JOINT REGIONAL PLANNING PANEL (East)

JRPP No	2014SYE149
DA Number	443/14
Local Government Area	North Sydney Council
Proposed Development	Reconfiguration of podium levels and new hotel tower: Alterations and additions to podium to include supermarket, retail and food premises with new hotel
Street Address	100 Miller Street North Sydney
Applicant/Owner	Cromwell Seven Hills Pty Ltd
Number of Submissions	Four (4)
Regional Development Criteria (Schedule 4A of the Act)	Capital Investment Value > \$20M
List of All Relevant s79C(1)(a) Matters	North Sydney LEP 2013 - Zoning – B3 Commercial Core North Sydney DCP 2013 S94 Contribution Railway Infrastructure Contribution SEPP 55 - Contaminated Lands SREP (2005)
List all documents submitted with this report for the panel's consideration	Conditions Plans
Recommendation	Approval
Report by	Geoff Mossemeneer, Executive Planner, North Sydney Council

Assessment Report and Recommendation

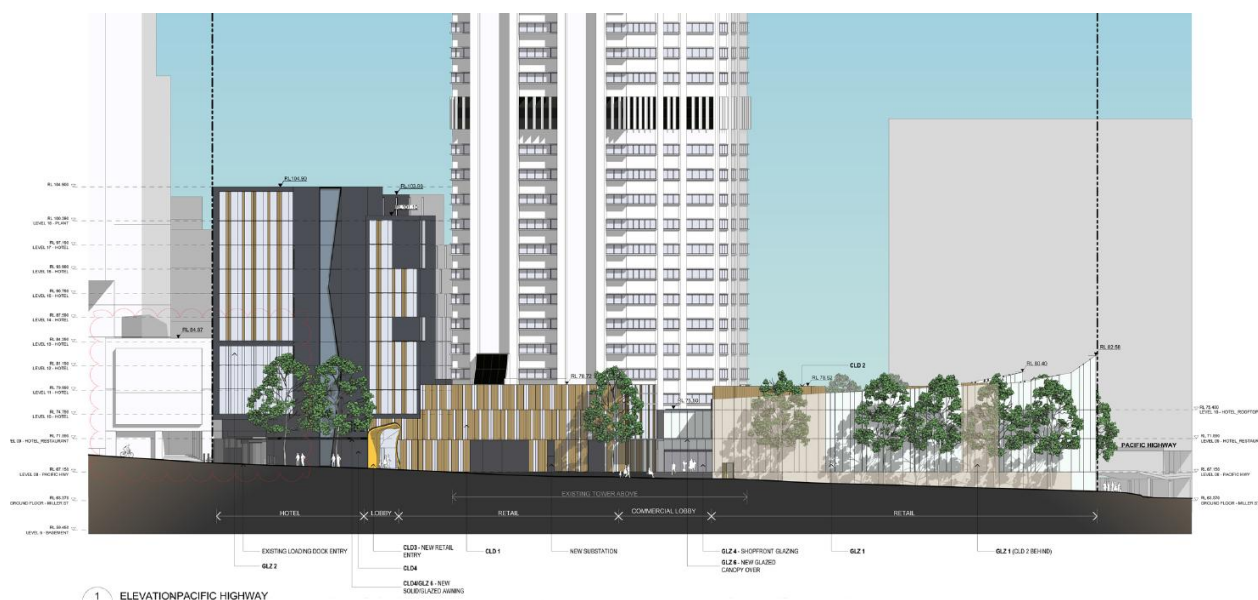
The applicant was requested to respond to the concerns raised by DEP. The applicant submitted their response on 27 March 2015 in the following terms:

- 1. The shard is to remain unchanged from the currently documented DA submission drawings (DA1-14, DA-15, DA-16, DA-17 & DA-18) for the following reasons:*
 - a. Architecturally the corner reinforcement responds to the surrounding buildings and context. The design makes a positive contribution to the public domain by giving back area to the public, thereby allowing spatial relief to this over-populated street corner.*
 - b. In collaboration with the extension of the kerb and enlargement of the traffic island, pedestrian amenity and safety is vastly improved. This opening up of the corner also provides future opportunity for further connection to the underground links to Greenwood Plaza and North Sydney Train Station.*

Amended plans have been submitted with regard to the hotel facade treatment that delineates a podium level through the introduction of different materials and banding as shown below:

The above treatment is considered satisfactory having regard to the reasons provided by the applicant above.

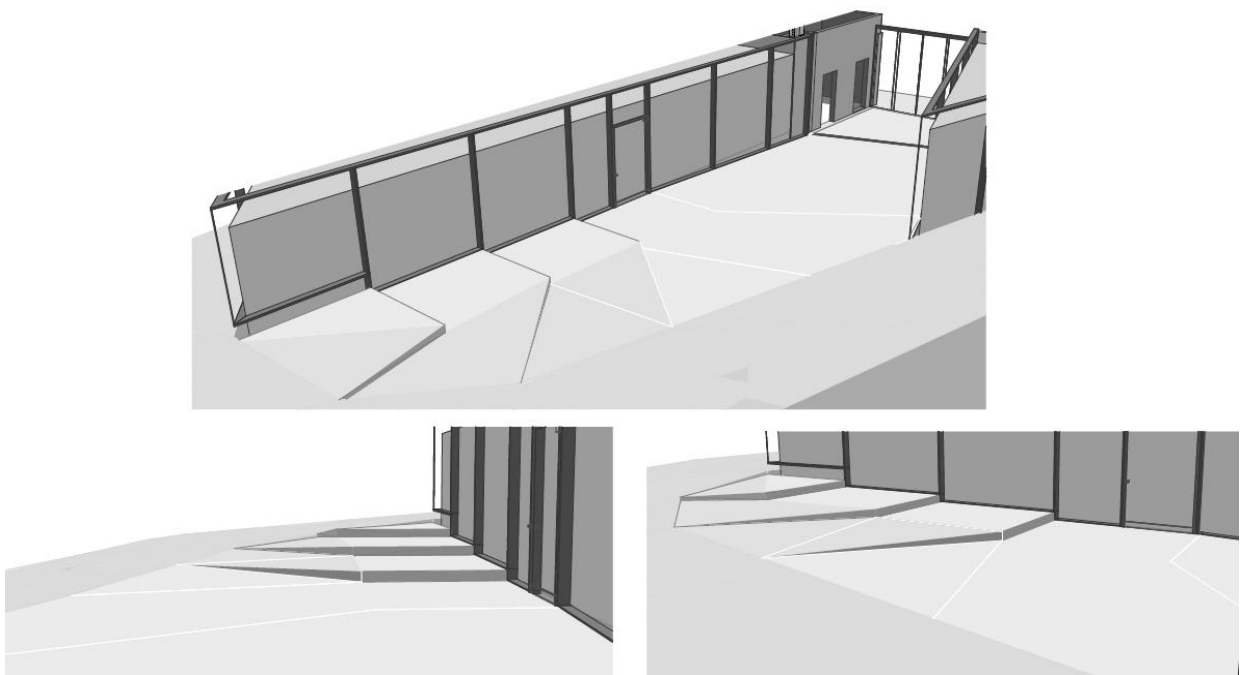
The proposal does not contribute a welcoming space to the public domain. Cafes on the corner may be active but not public, and their acute internal corner spaces would be unusable. It would be exposed to the strong winds and rain, whereas the existing building does provide some shelter. It would focus views from the opposite side of the intersection towards the existing unprepossessing tower. The comments previously provided by the Panel at the last meeting are still relevant.

The Panel notes that steps are proposed for half the opening to the retail space at the corner. Further detail is required of these corner steps and how they are to be treated with balustrades and ramping. It would seem that this area where the levels are so difficult should be enclosed within the site. This would also allow for the corner to be strengthened and the narrower opening to be secured after hours. Enclosure of the corner for at least two levels would be a preferred solution.

This critical corner component should be firmly expressed rather than eroded by an open space, with a building form which screens the direct view of the existing tower, and has a welcoming covered entrance at street level, rather than a potentially bleak and uninviting gap that will be lined by things for sale and a pair of lift doors. A stronger definition of an elegant structure than is at present proposed could increase the clarity of the entrance and of the internal space throughout, without reducing the intended "glassiness".

A realistic view of the entrance as seen from the footpath just outside the entrance should be submitted.

The comments of the DEP are supported, there is a real concern over the safety of the steps/ramp right at the corner where pedestrians will cross at the lights. The preference is for this difficult area to be enclosed as part of the corner tenancy. That enclosure could be over two levels to the height of the required awning. If the area is to be left open, it must be identified with rails/balustades and simplified to just steps with small retaining wall or planter to deal with level change. The steps should be inside the site as much as possible with the stairs together rather than spread apart. The applicant has declined to make the changes recommended by the Panel. As a minimum to address some of the concerns, the entrance needs to be redesigned to have a set of stairs over part of the entrance (within the site) with the continuous awning along the full frontage and over the entrance at a lower height than proposed and covering the footpath to the same degree as the street awnings. This can be conditioned.
